**Raport de evaluare: Studiu de evaluare a impactului asupra mediului
pentru proiectul Rosia Montana**

Grupul Independent al Experților Internaționali (IGIE)

Raport pregătit pentru comitetul ad hoc al experților (Proiectul Roșia Montana), convocat de
Guvernul Ungariei și Guvernul României, 30 Noiembrie 2006

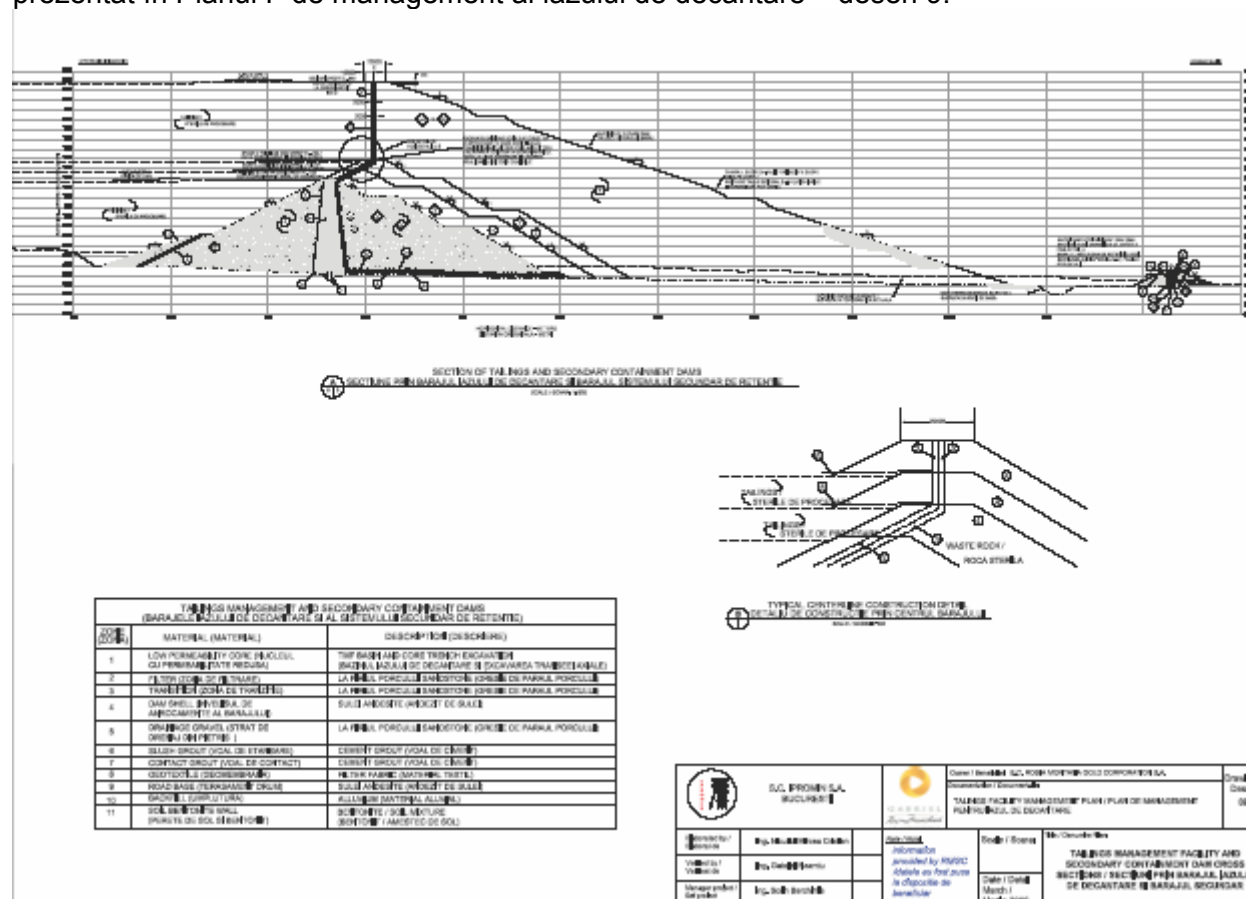
Recomandare 14 (Îngrijorare VI) În analiza statică făcută până în prezent, nu au fost luate în considerare efectele infiltrațiilor. Se consideră că trebuie acordată atenție faptului că acest lucru este acceptabil doar cu condiția ca elementele de drenare care extrag apele de exfiltrații din corpul barajului sunt eficiente și de încredere pe termen lung. În aceste circumstanțe apare ca recomandat un strat de drenaj de fund în întregul fundament din aval și un dren la extremitatea din aval a taluzului (material : pietriș făcut din rocă durabilă sfărâmată sau din pietriș natural).

Taluzul aval al barajului iazului de decantare include un filtru vertical și un strat de tranziție care va fi compus din rocă concasată exact în aval de miezul cu permeabilitate scăzută. În plus, un strat de dren este incorporat la baza umpluturii de rocă pe întreg taluzul aval.

Rezultatele analizelor de infiltrație (presiunea hidrostatică în baraj) au fost incorporate direct în analizele de stabilitate atât dinamice cât și statice.
O secțiune transversală de detaliu prin barajul final și prin cel secundar (inclusiv zonele de filtre) este prezentat în Planul F de management al iazului de decantare – desen 9.

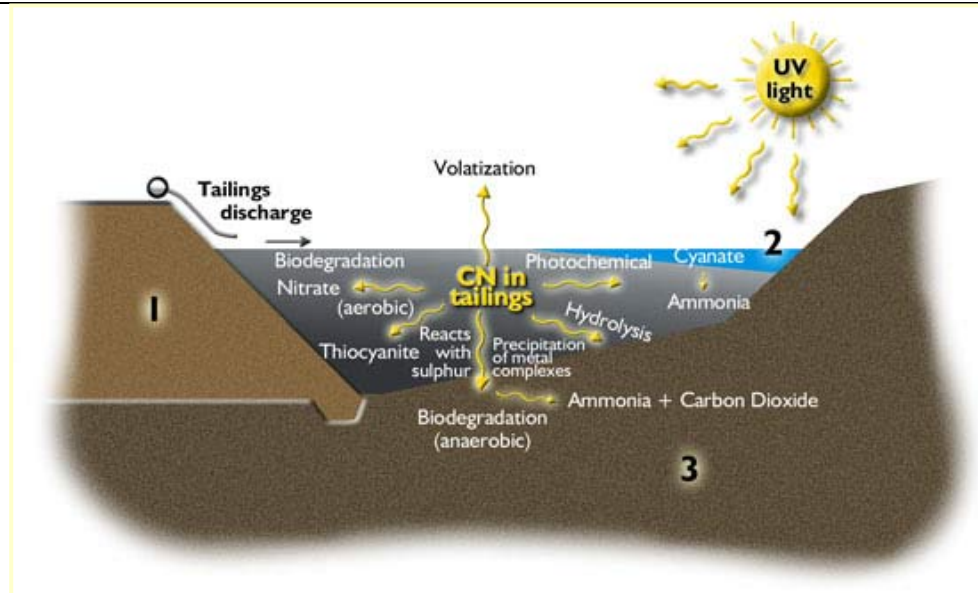
The cyanide balance description needs clearer accounting the amount of cyanide that is to arrive to the TMF, what amounts of cyanide leave the TMF, in what manners (surface attenuation, dissociation, recirculation, etc) breakdown occurs. At present there is no clear view on what the possible effects of existing sulphide minerals (if any) might be, and how these minerals might affect the cyanide dosage and/or concentrations.

The cyanide balance diagram is in Chapter 2 of the EIA Report with the accompanying text which erroneously refers to 'Fig 2.7'. This outlines the annual cyanide life cycle. The mineralogy and chemistry of the ore and variability of these in regard to CN dosage in the process has been determined by test work carried out in specialist laboratories.

Cyanide will be used in the Project for the carbon-in-leach (CIL) process (between 11 and 13 thousand tone/ year – less than 200 thousand tons over the mine life) in the extraction of gold. Most cyanide will be recovered in the plant as illustrated in Exhibit 4.1.15 and discussed in Section 2.3.3, Chapter 4.1 Water, of the EIA report, however, a residual will remain in the tailings. Residual cyanide concentrations in the treated tailings slurry will be subject to compliance with the EU Mine Waste Directive which stipulates a maximum of 10 ppm WAD CN. Cyanide will be present as a potential pollutant at the site in (artificial) surface water only during the operational phase and the first year or two following closure. Modelling of the predicted concentrations in the TMF has shown that treated process plant tailings flow is expected to contain 2 to 7 mg/L total cyanide. Further degradation will reduce the concentrations to below applicable standards in surface water(0.1 mg/l) within 1-3 years of closure. A secondary effect of this treatment is also the reduction of many of the metals which may potentially occur in the process water stream. An assessment of the likely chemical makeup of the tailings leachate, based on testing, is summarized in Table 4.1-18 (section 4.3.), Chapter 4.1 Water, of the EIA report. The below drawing is presenting the complexity of CN degradation processes which are occurring in TMF.

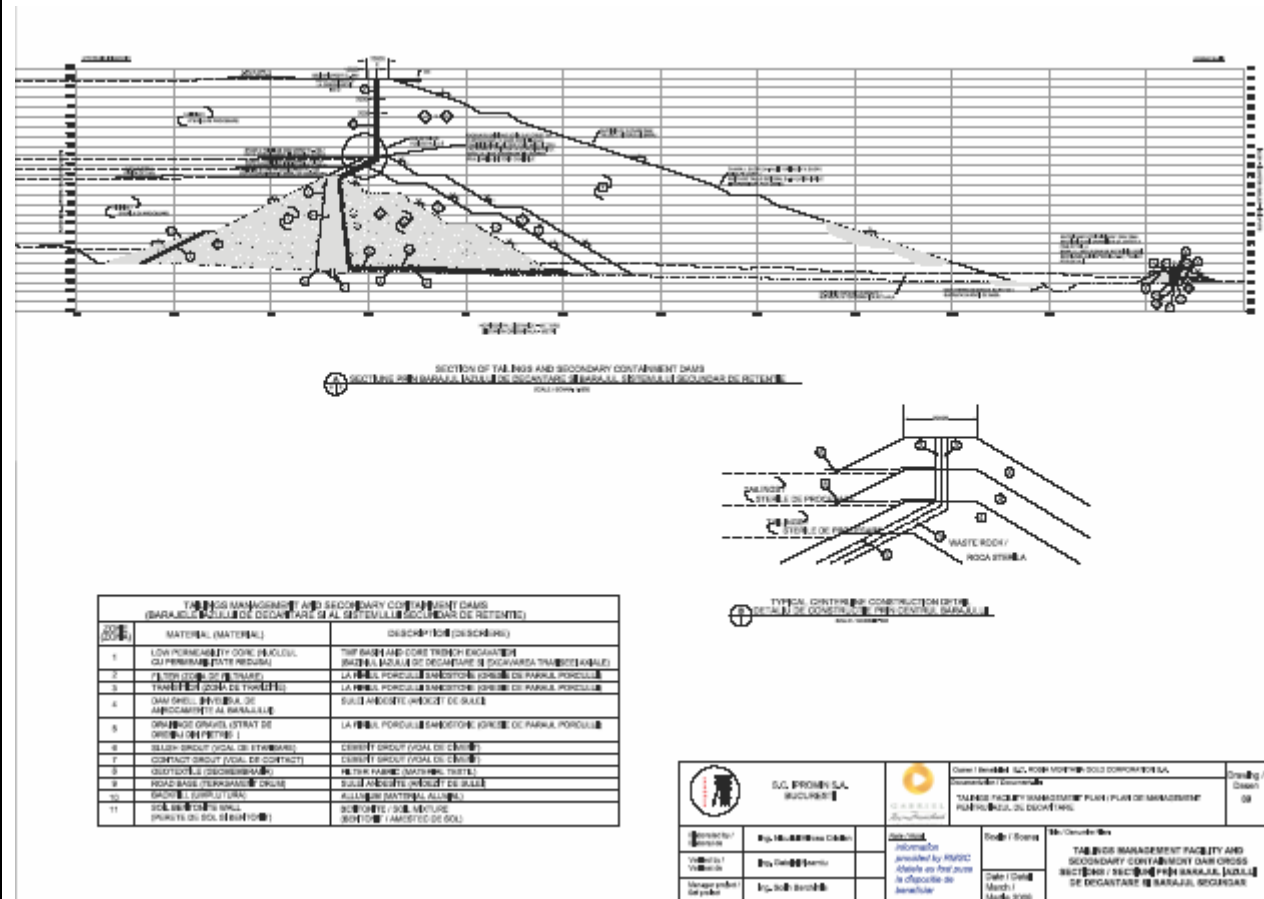
Recommendation 14 (Concern VI) In the static analysis performed so far, no seepage effects appear to have been taken into account. It is deemed that attention must be drawn to the fact that this is acceptable only under the condition that drainage elements to draw off seeping waters from the dam shell body that are reliable and effective in the long term are provided. In this instance a bottom drainage layer in the whole downstream base and drain toe at the downstream slope end appears advisable (material: gravel made from crushed durable rock or natural gravel).

The downstream slope of the TMF embankment includes a vertical filter and transition layer that will be composed of crushed rock just downstream of the low permeability core. In addition, a blanket drain is incorporated into the base of the rock fill over the entire downstream slope.

The results of the seepage analyses (hydrostatic head within the dam) have been incorporated directly into the stability analyses for both the static and dynamic analyses. A detail cross section of the final dam and SCD (including filters zones) is presented in the TMF management Plan F- drawing 9.
